Application No.	Applicant(s)
Notice of Allowability	10/080,089	MCKAY, WILLIAM D.
	Examiner	Art Unit
	Randall Chin	1744
The MAILING DATE of this communication All claims being allowable, PROSECUTION ON THE MER herewith (or previously mailed), a Notice of Allowance (PT NOTICE OF ALLOWABILITY IS NOT A GRANT OF PAT of the Office or upon petition by the applicant. See 37 CF	RITS IS (OR REMAINS) CLOSED in OL-85) or other appropriate comministry (ENT RIGHTS. This application is a second control of the control of th	n this application. If not included unication will be mailed in due course. THIS

Randall Chin Primary Examiner Art Unit 1744 LINT REMOVAL APPARATUS WITH PULL TAB FOR ADHESIVE COATED SHEETS Inventor: McKay App. No: 10/080,089; Our Ref: 4316/094

FIG. 2

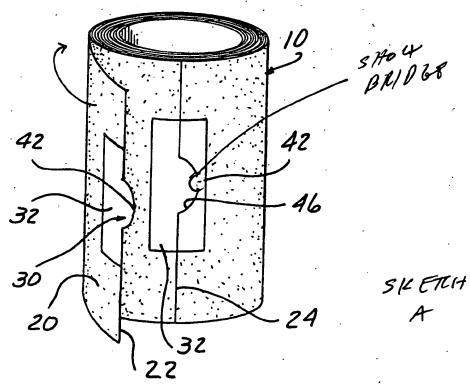
Continuation of Attachment(s) 9. Other: the proposed drawing corrections to Figs. 1-3 filed 27 April 2005 are approved. Formal drawings are now required and should include the approved drawing corrections of 27 April 2005 as well as 14 October 2004.

. Not approved
